TENNESSEE VALLEY AUTHORITY

TVA BFNP TS 123

In accordance with the provisions of 10 CFR Part 50.59, we are enclosing 40 copies of a requested amendment to licenses DPR-33, DPR-52, and DPR-68 to change the technical specifications of Browns Ferry Nuclear Plant units 1, 2, and 3 (Enclosure 1). Also enclosed are justifications for the proposed changes (Enclosure 2). The enclosed changes consist of administrative changes, clarification changes, NRC requested changes, and changes to reflect new plant organization.

PROPOSED CHANGES TO BROWNS FERRY

#### 1. Reports on the following areas shall be submitted as noted:

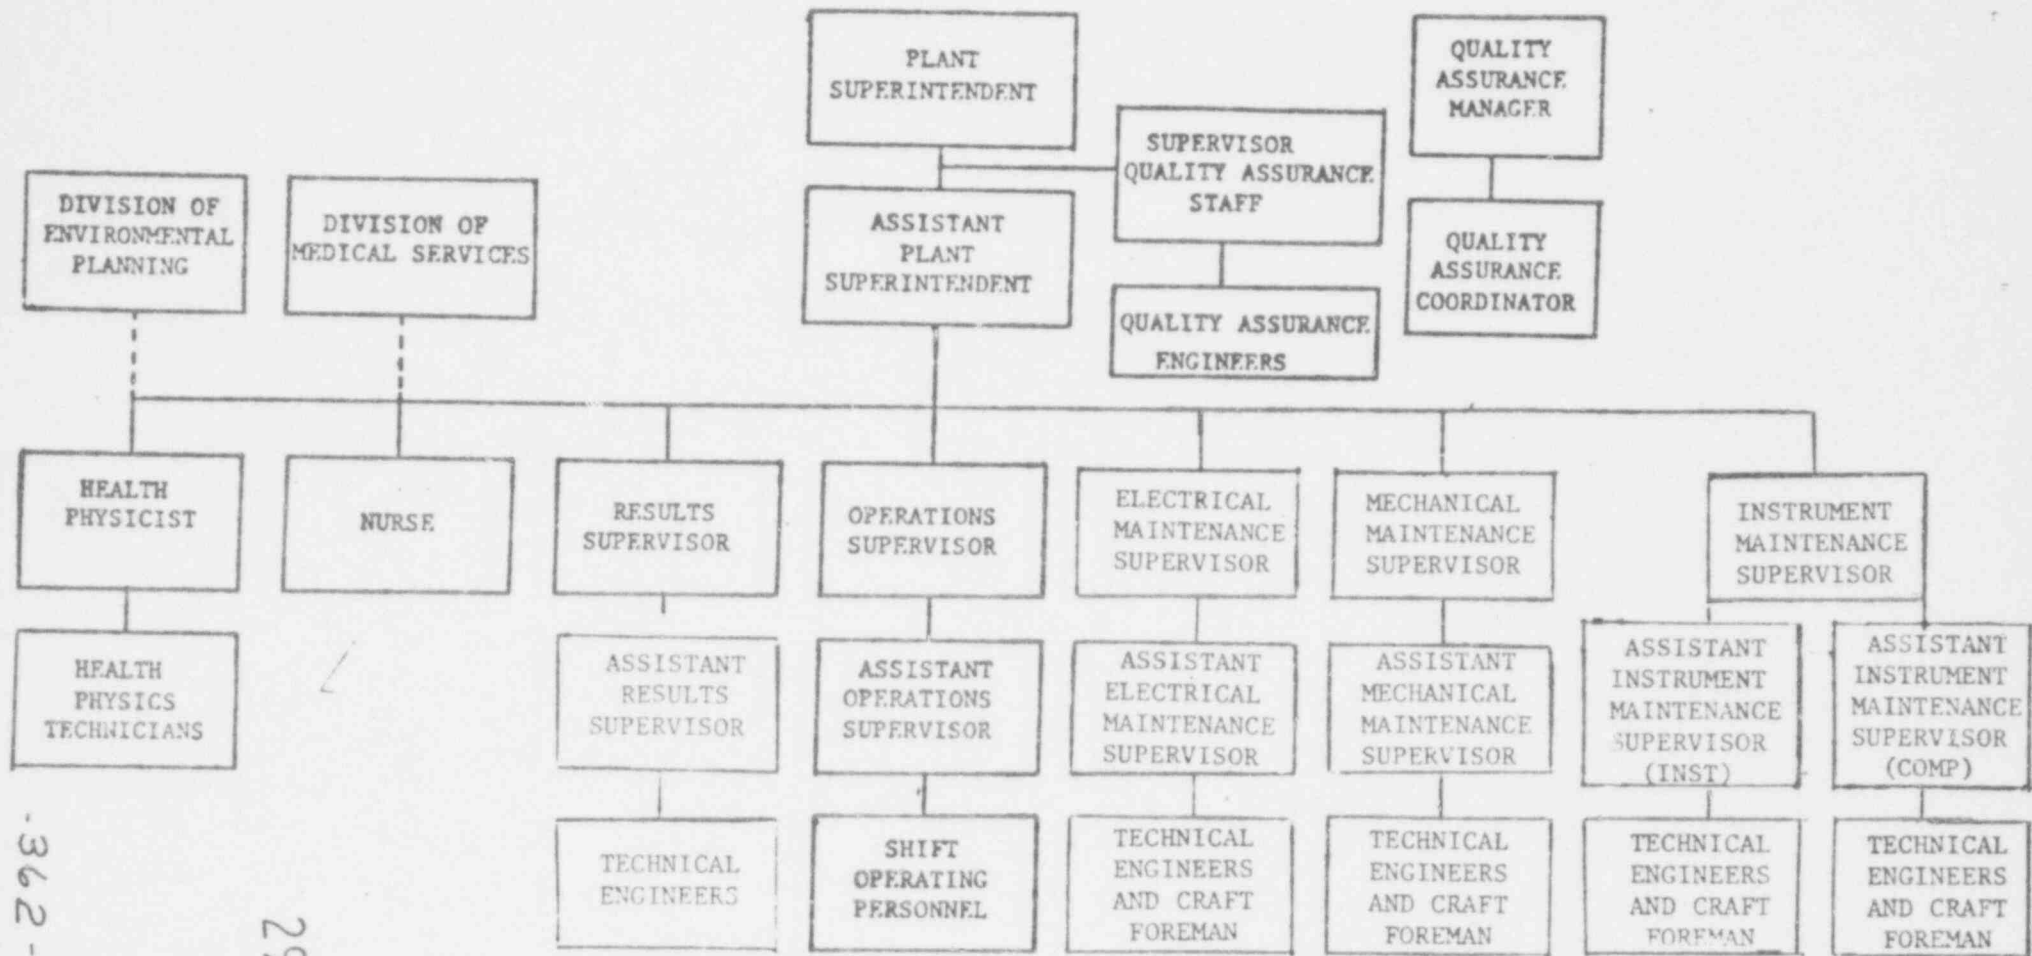
- Pages 348, 351, and 356 - - - - - It is proposed to change paragraph 6.6.A.17.b(3) and 6.7.3.C.1.b from a frequency of "annual operating report" to "monthly operating report" to further comply with NRC's letter from A. Schwencer to G. Williams dated September 16, 1977. It is also proposed to add paragraph 6.7.1.b(2) in order to report cumulative fatigue usage factors for the reactor vessels monthly in the monthly operating report.

| b. Fatigue Usage<br>Evaluation                    | 6.6     | monthly<br>Operating<br>Report                      |
